**Re: Peer Review of Stormwater Management Permit Application
Nobscot Scout Reservation Trail Improvement Project
1 Nobscot Road, Sudbury, MA**

Howard Stein Hudson (HSH) has reviewed the Horsley Witten Group comments on behalf of the Town of Sudbury dated October 11, 2022 and offers the following responses:

SITE PLAN FOR NOBSCOT SCOUT RESERVATION TRAIL PROJECT SUDBURY AND FRAMINGHAM, MA.

BELDEN BRIDGE SECTIONS
NOT TO SCALE

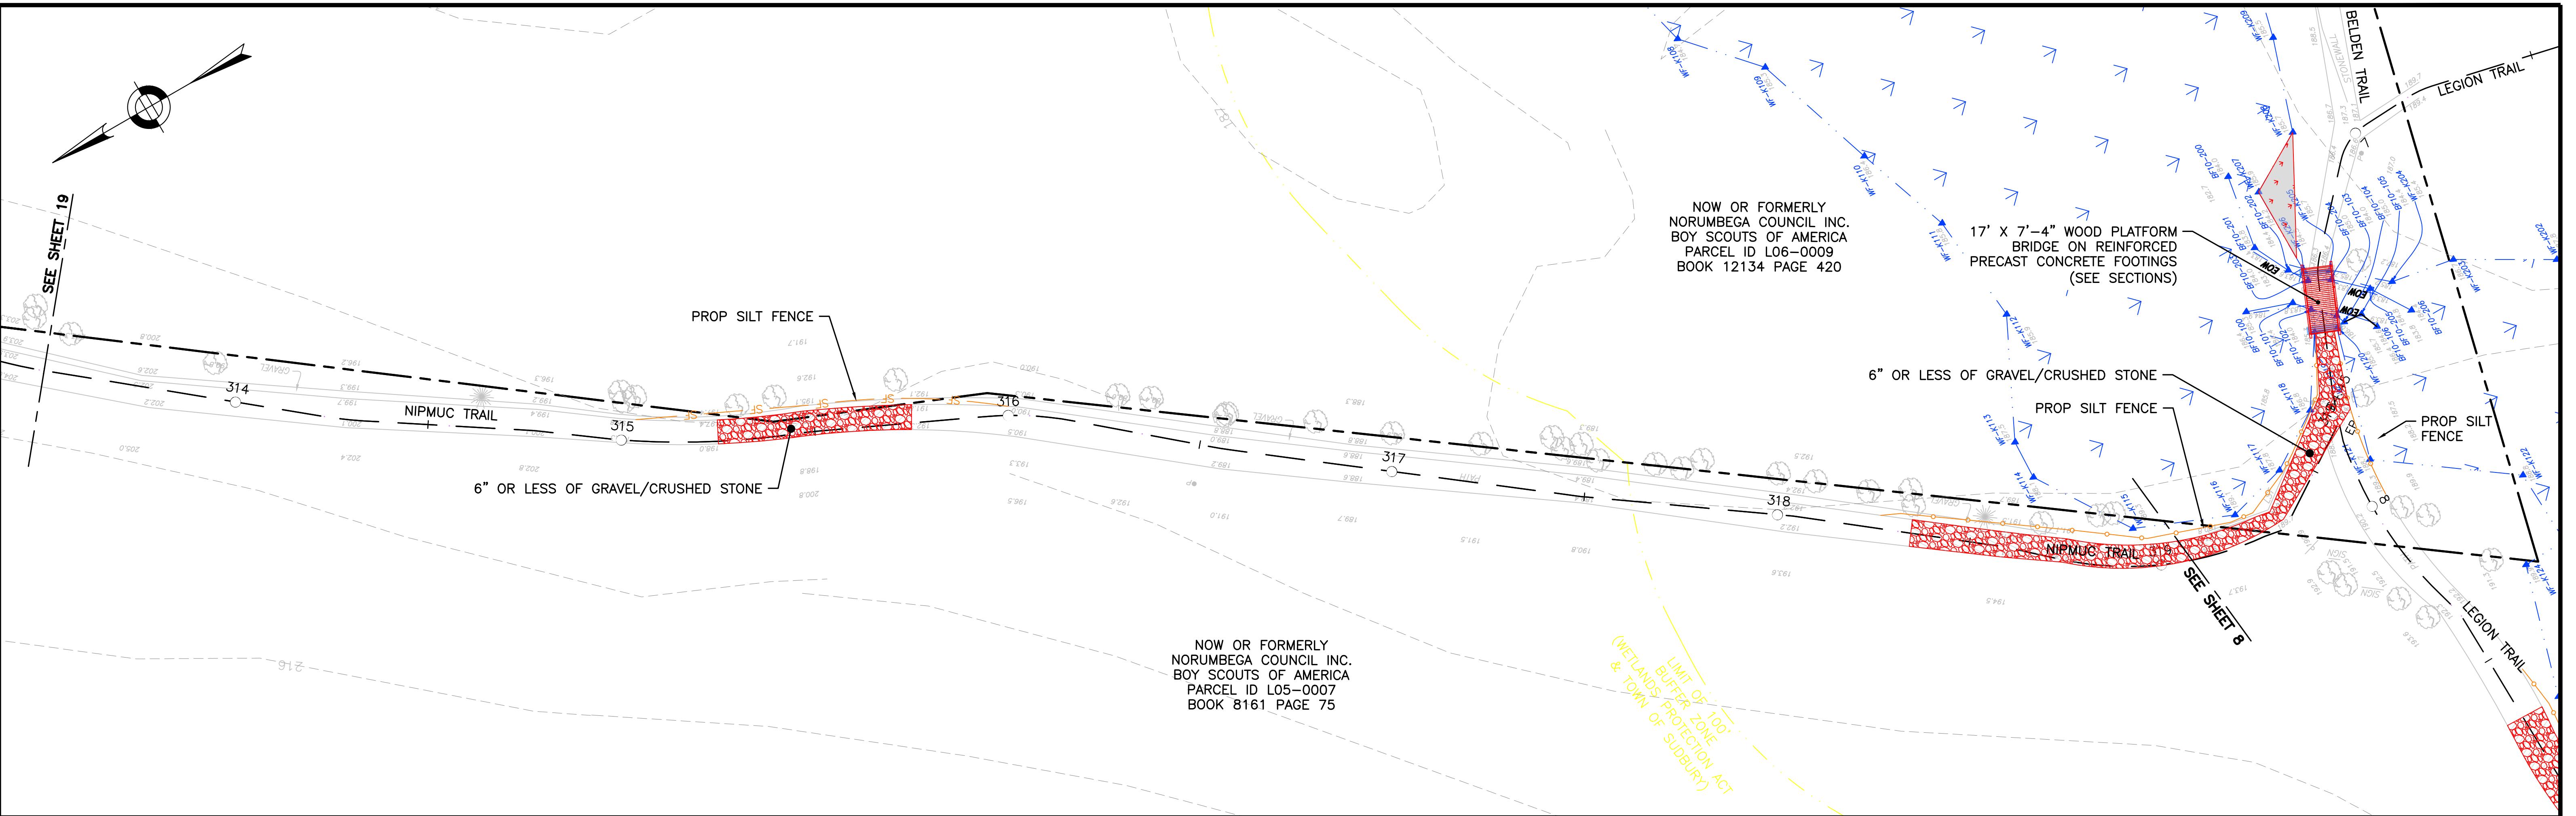
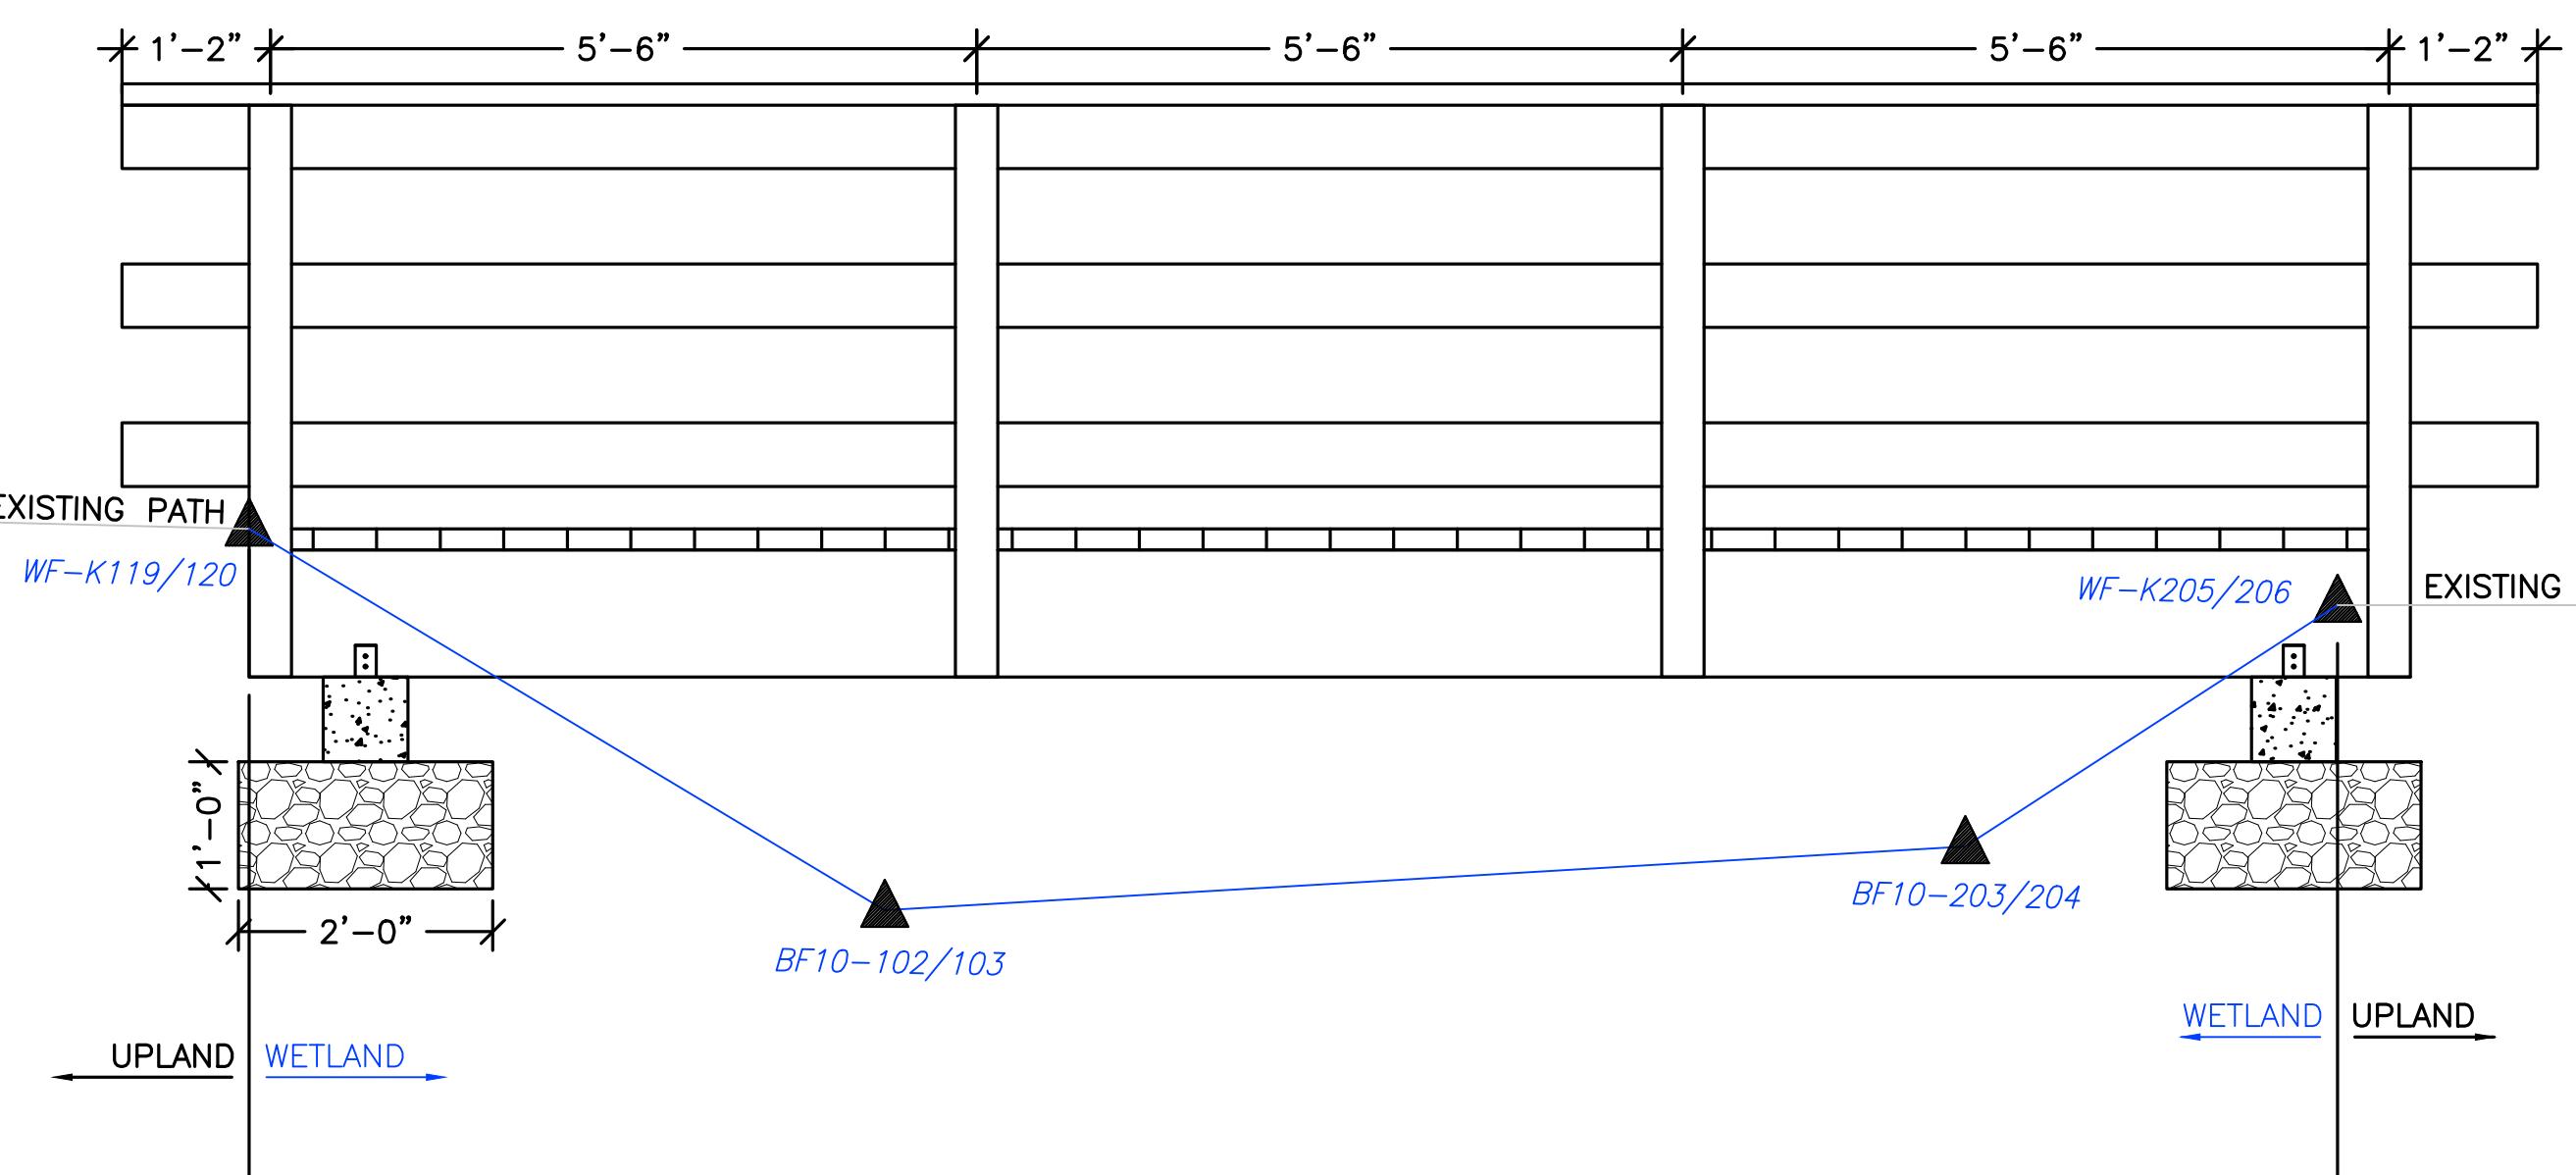
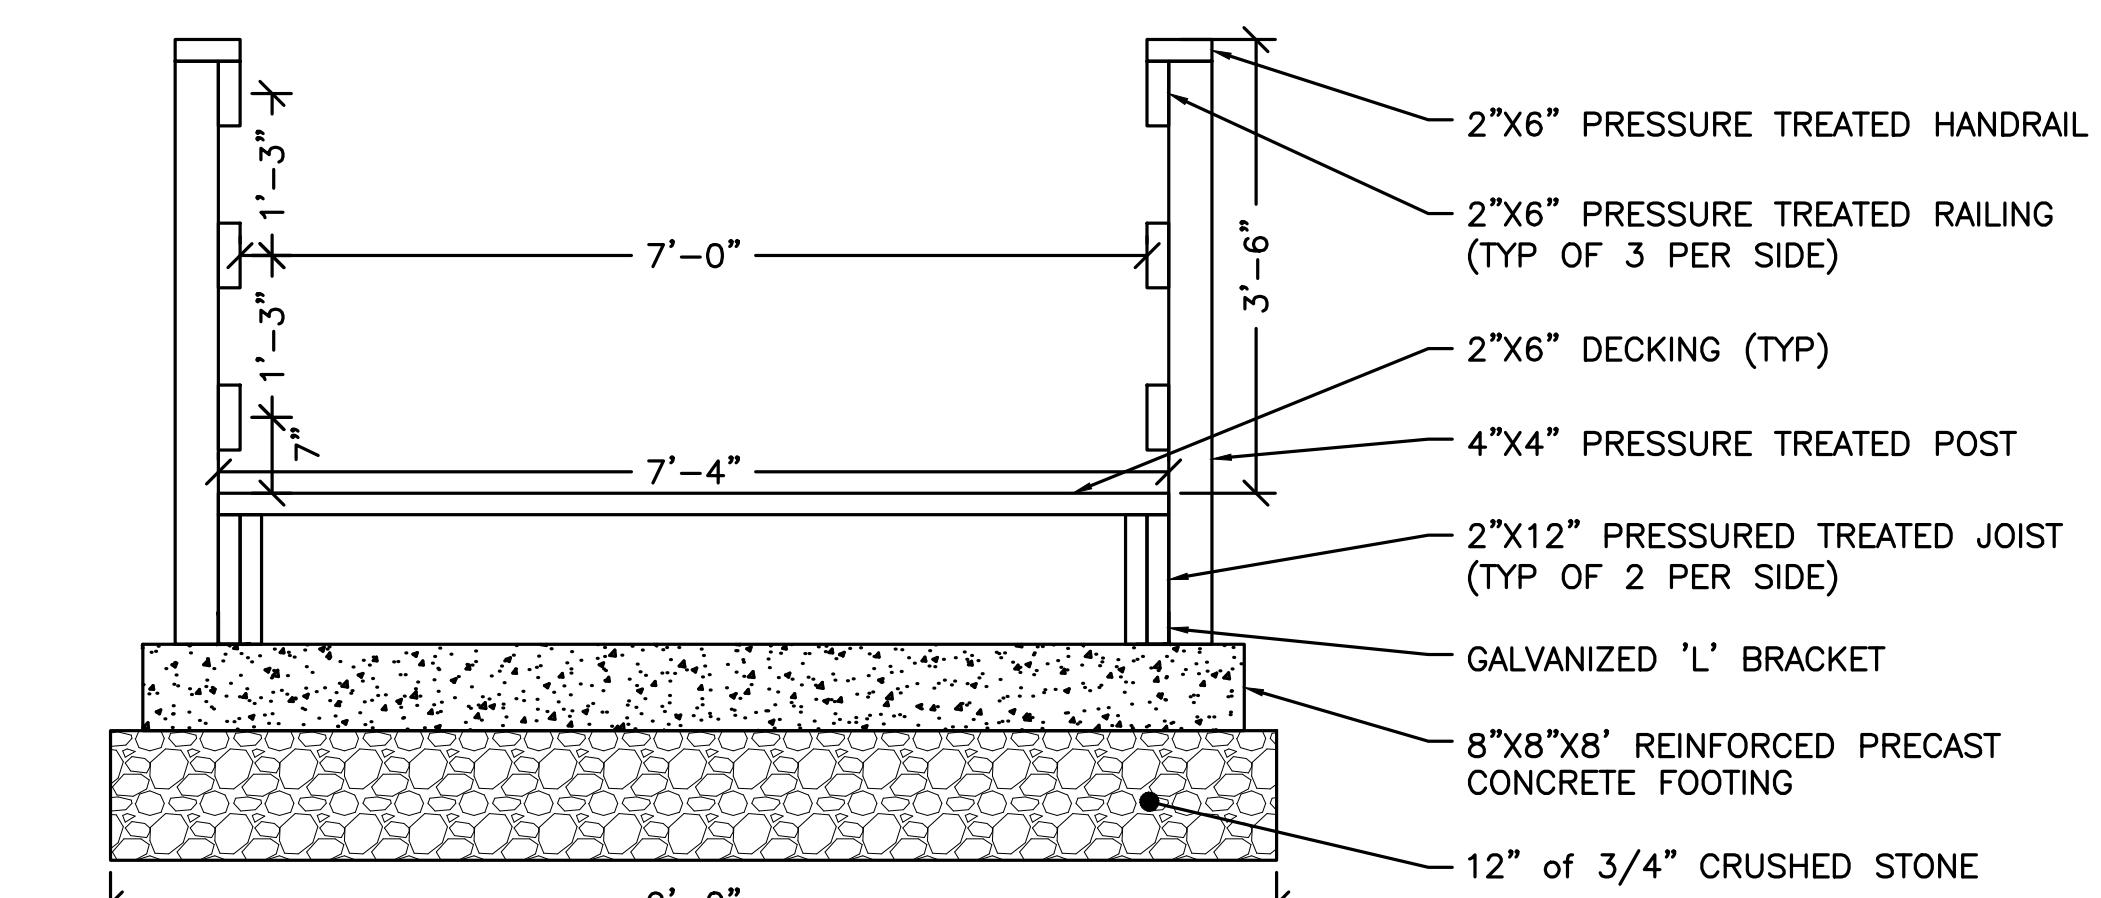
Sheet 20 of 21: NIPMUC Trail – Station 314+00 to 319+00 and Belden Bridge

Comment: *Applicant intends to remove utility pole and fill void left by pole with precast concrete footing.*

Comment: *Area that appears to be used by dogs to access stream should be planted with native vegetation that will discourage access. Within or adjacent to proposed wetland mitigation area.*

Response: **Correct, all proposed bridges specify precast concrete footings.**

Response: **Planted vegetation will not provide a barrier to prevent dogs from entering the stream. All dogs are to be leashed within the Nobsco Trail Reservation. Applicant suggests placing a new sign to alert walkers to leashing their dog and to keep the dogs out of the stream.**

TURTLE BARRIER ENTRANCE DETAIL
NOT TO SCALE

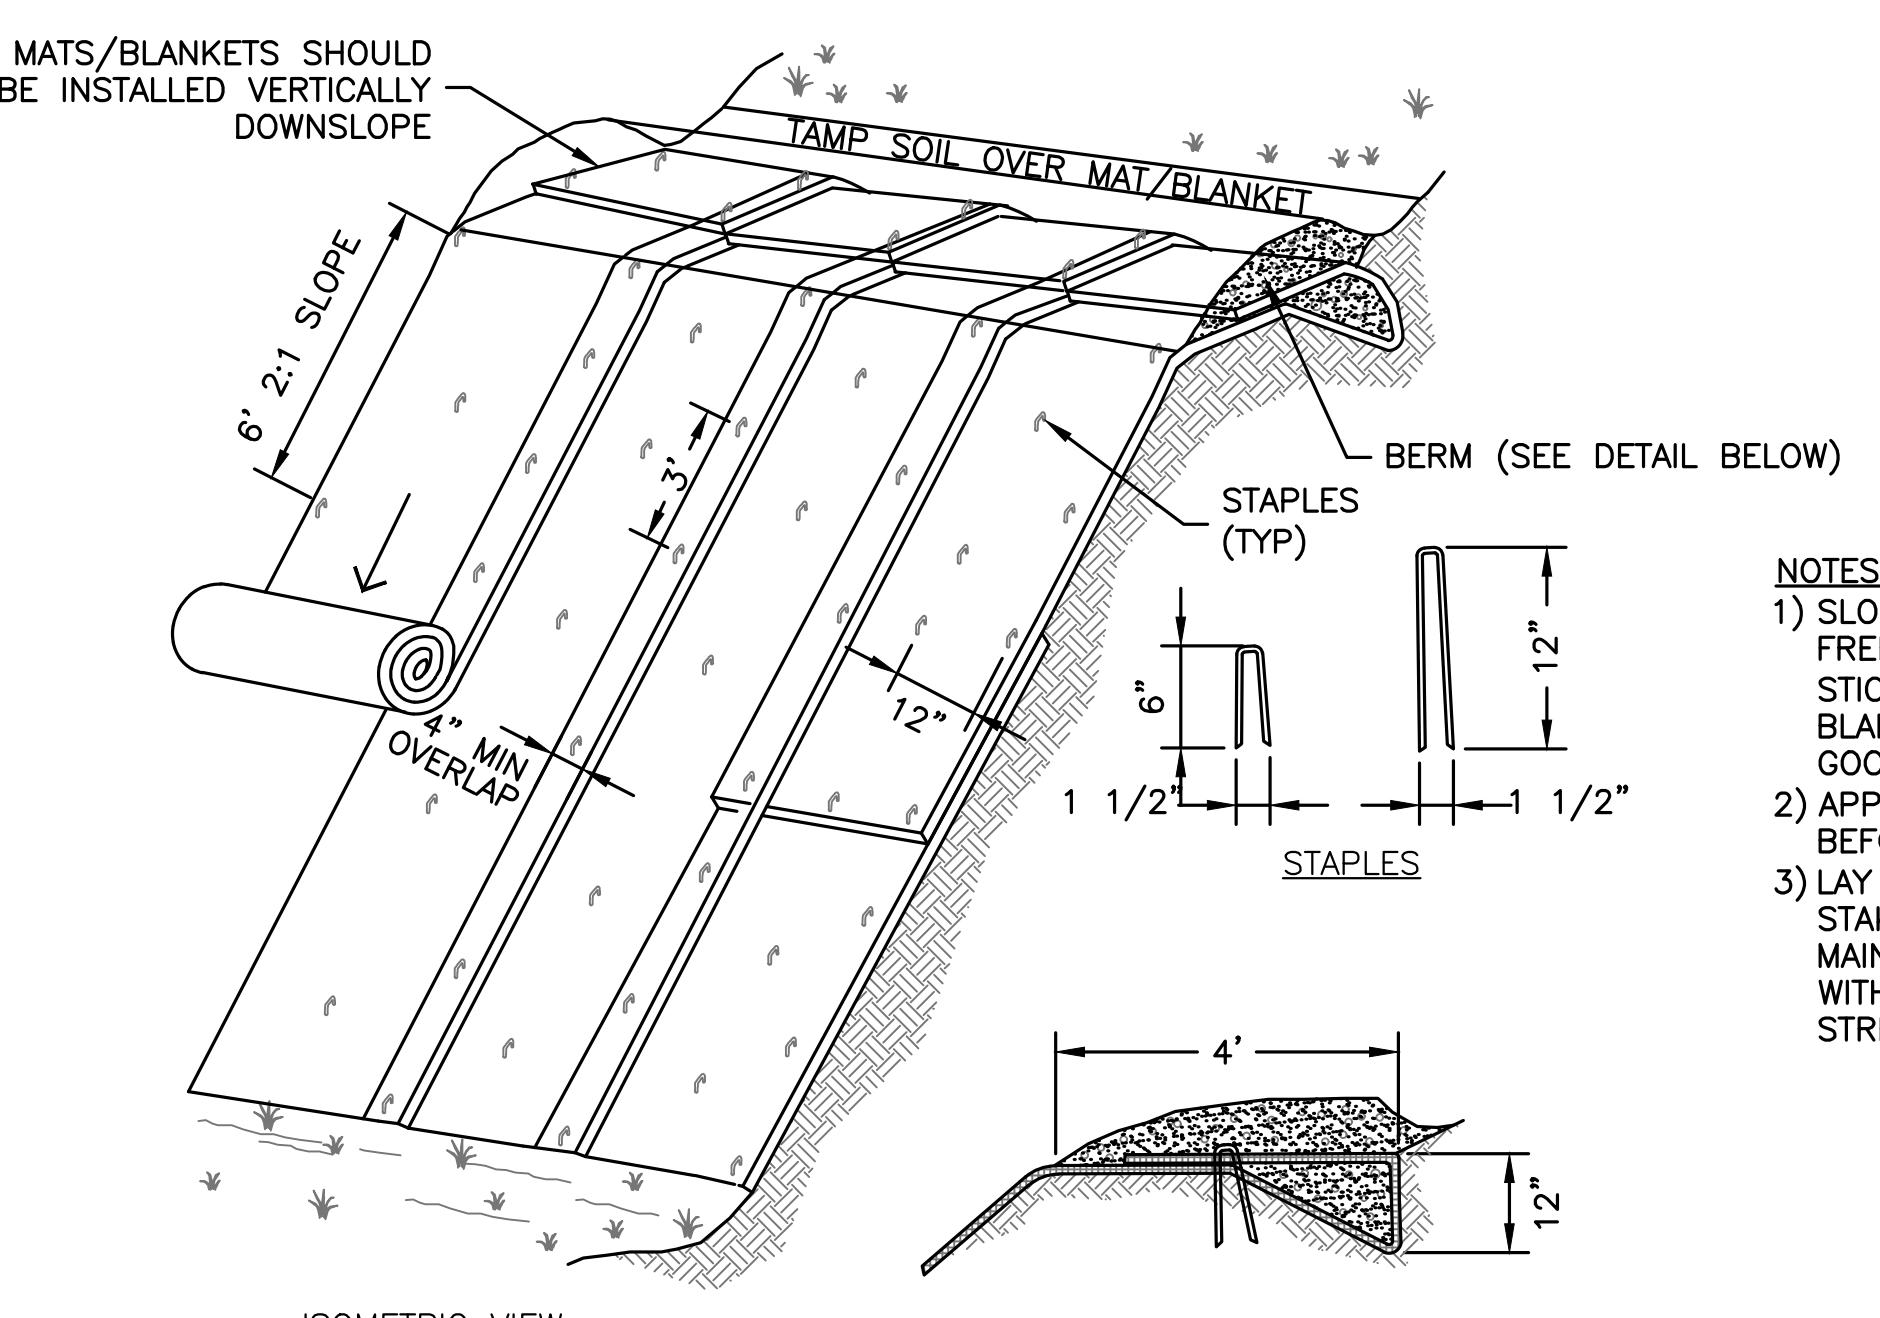
Comment 21: *Erosion controls within wetlands should not include trenching of silt fence. Okay to weigh down with silt sock. Measures to be taken to protect turtles during construction.*

Response: **Silt fence details has been revised to eliminate trenching previously shown to be replaced by compost filter tubing staked in place where necessary. A turtle barrier entrance detail has been added to the Details sheet.**
